From: Enya Fogarty
Sent: 17 July 2023 09:19
To: Planning Planning
Subject: FW: Objection to 2023/2245/P
Attachments: Daylight Sunlight Overshadowing Report - Grounds for Objection.pdf;
Updated Core Objections to Drury Works.docx

Core objections to planning scheme 2023/2245/P

redevelopment of the office block at 160-161 Drury Lane London WC2B 5PN.

Planning Application - 2023/2245/P
Proposed Development at 160-161 Drury Lane London Camden WC2B 5PN
Impact on Parker Street & Drury Lane Residents

Proposed Extension

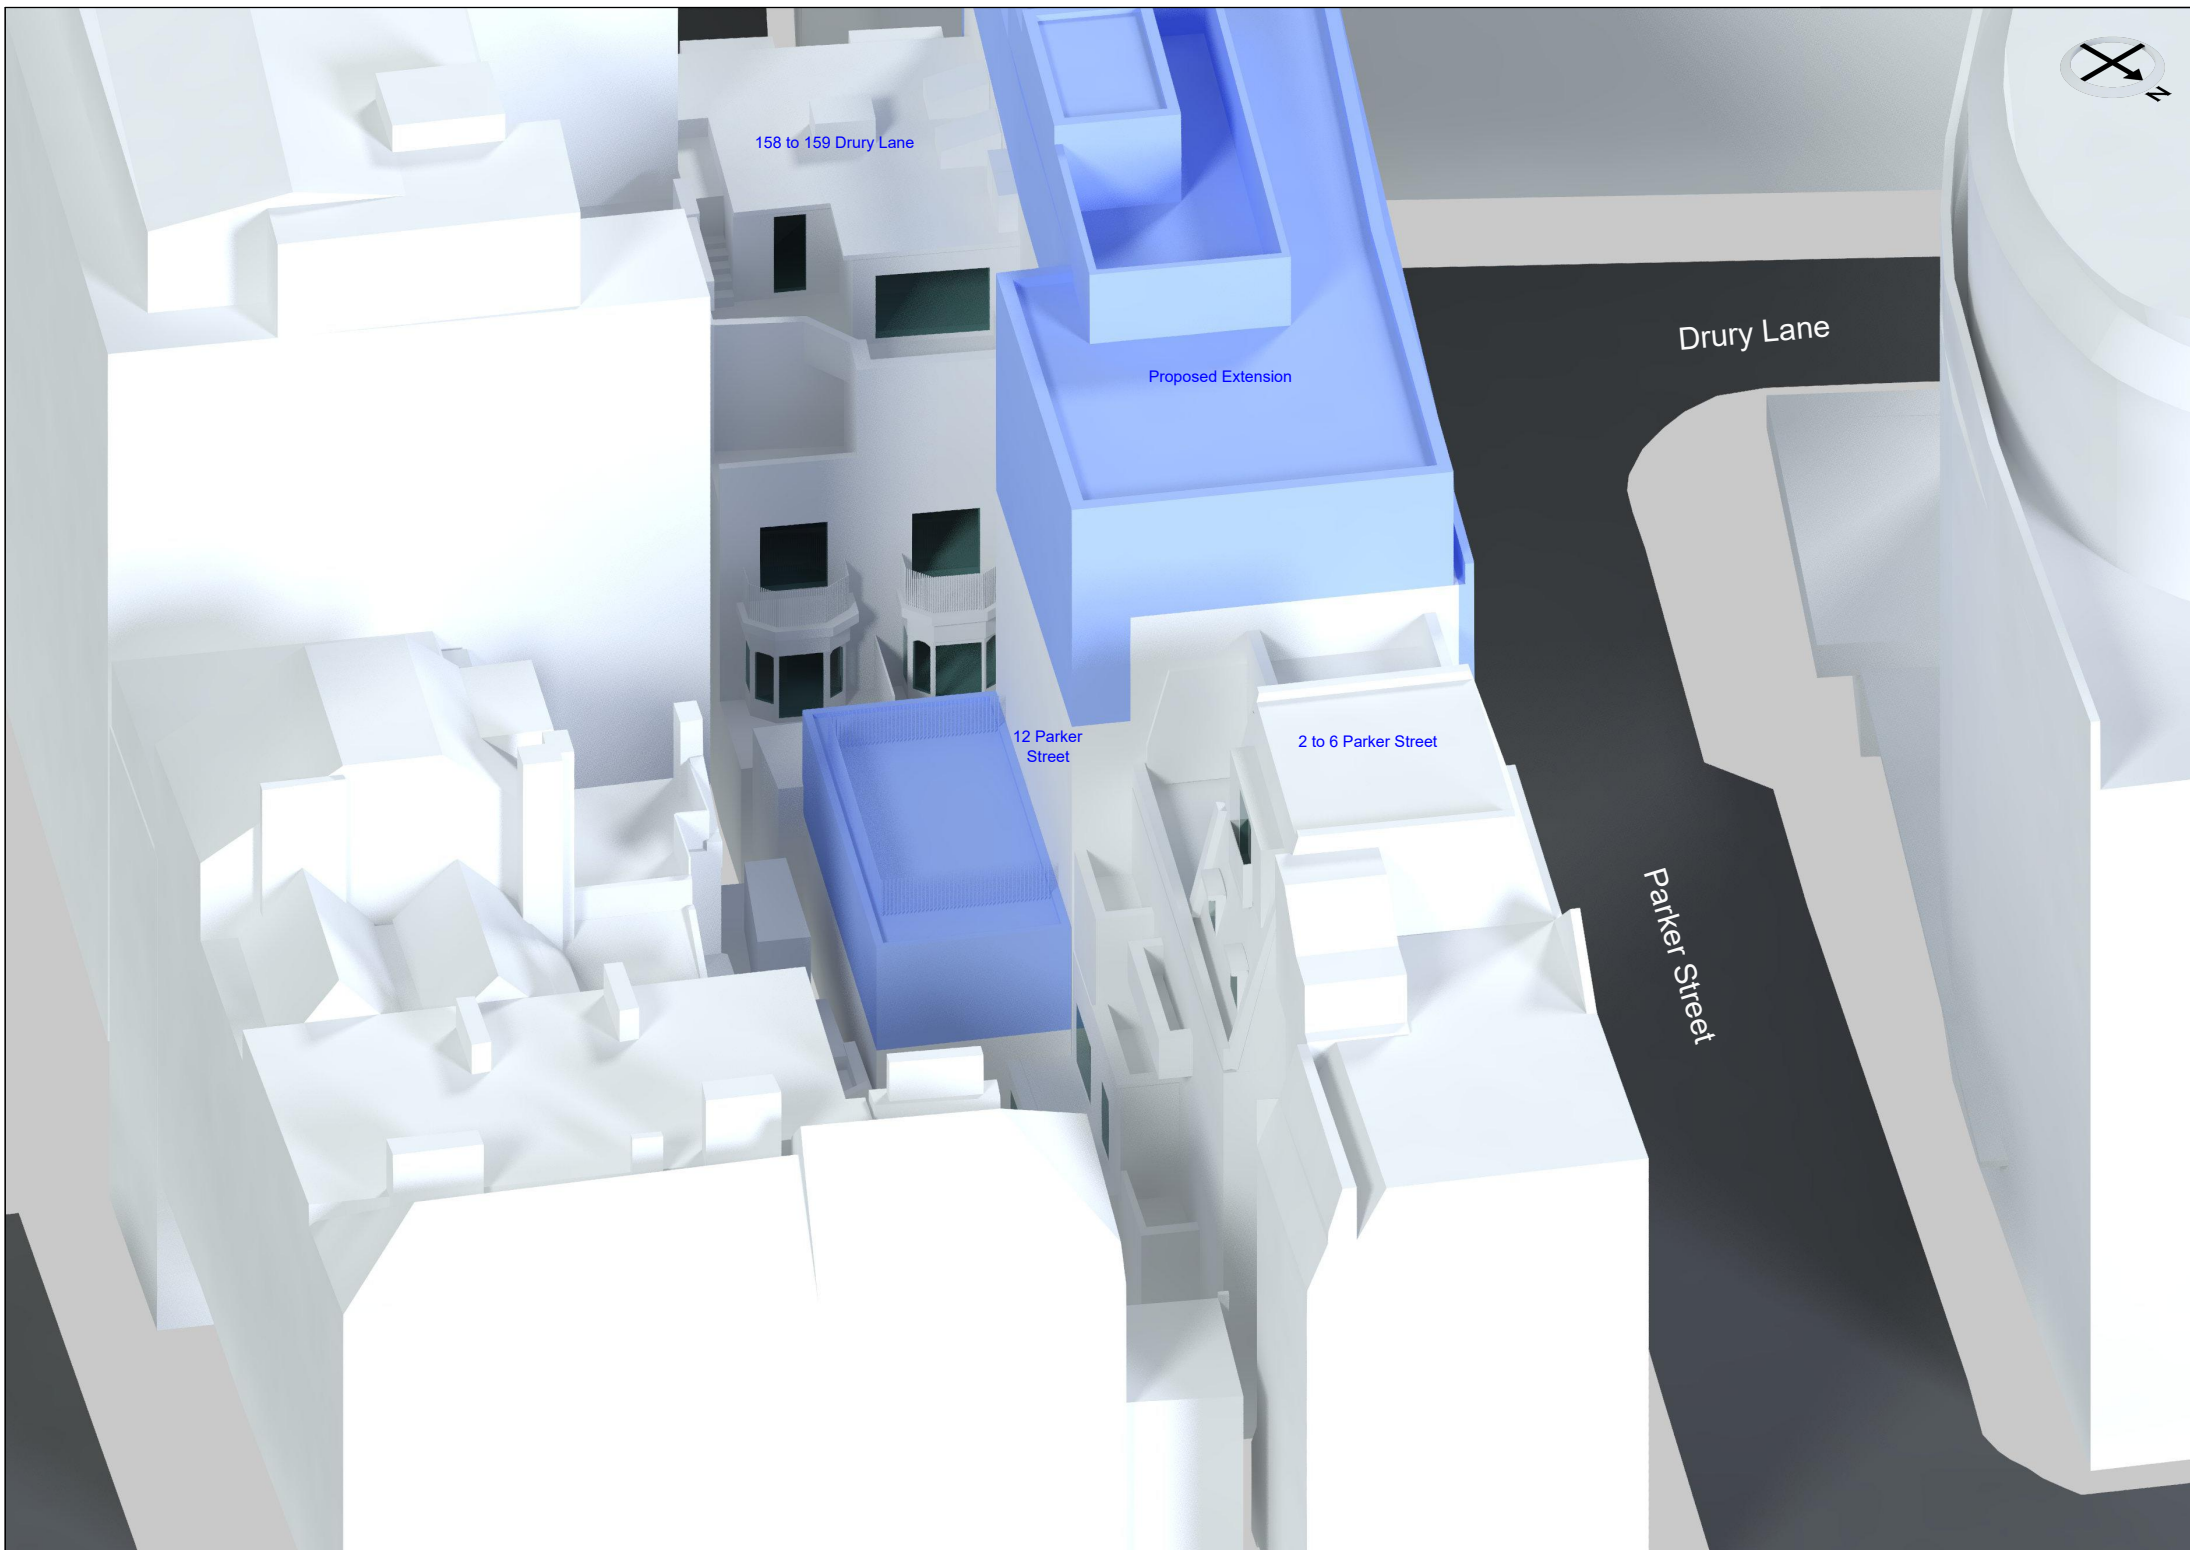
At section 8.24 – Point 2 states that both windows W6/254 [Window 11] (4th floor) & W1/255 [Window 16] (5th floor) are within 10% of the 0.8 permitted ratio loss. However, there is a significant difference between our results for W1/255 [Window 16] (5th floor primary window leading in the terrace) and those of Point 2. Our results confirm that the window serving the Studio is both greater than 10% within the 0.8 permitted ratio loss and significantly less light following the development in absolute terms. Our results are as follows: a VSC of 23% before the development and 15.7% after the development [7.3% absolute loss & 32% relative reduction in formerly enjoyed light] whereas Point 2's report states that the window has a VSC of 32.28% before the development and 23.68% after the development 8.6% absolute loss & 26.64% relative reduction in formerly enjoyed light].

The results of our analysis have revealed an additional transgression of the BRE Guide not identified within Point 2's report. Namely, window 31 in Flat 5 on the fourth floor of 158-159 Drury Lane. The window enjoys a VSC value of 23.9% before the development, which is reduced by 5.1% down to 18.8% after the development which is equivalent to a 21% loss of the formerly enjoyed daylight to this window. This represents a material loss of light.
